DESCRIPTIVE REPORT

Registry No. H-10940

General Locality Southwest Prince William Sound

Sublocality Little Green Island and Vicinity

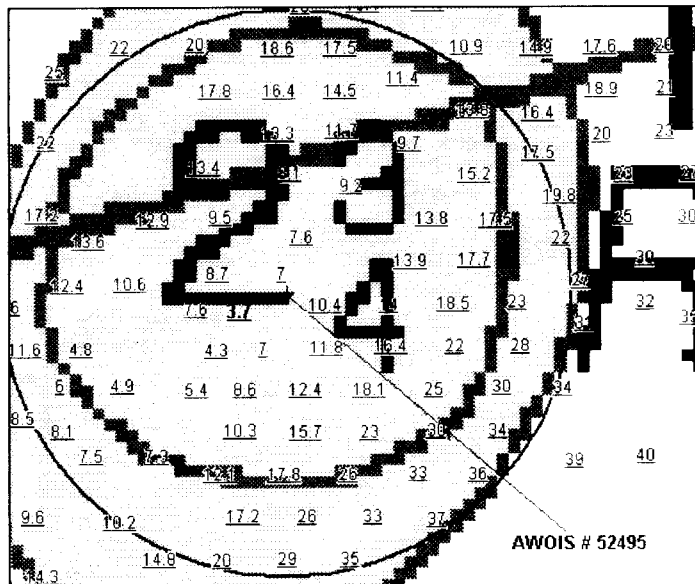
7. Comparison with the Chart and Charting Recommendation: Compared with chart 16701; 17th Ed.; July 25, 1998; 1:81,436. The chart shows a 2 3/4-fathom shoal reported at 60°11'07.03"N, 147°34'01.72"W.

The Hydrographer recommends charting the shoal at 60°11'04.85"N, 147°34'04.15"W using contemporary survey depths. *concur*

Chart 3 1/2 rky

See Eval Rpt, Section IV
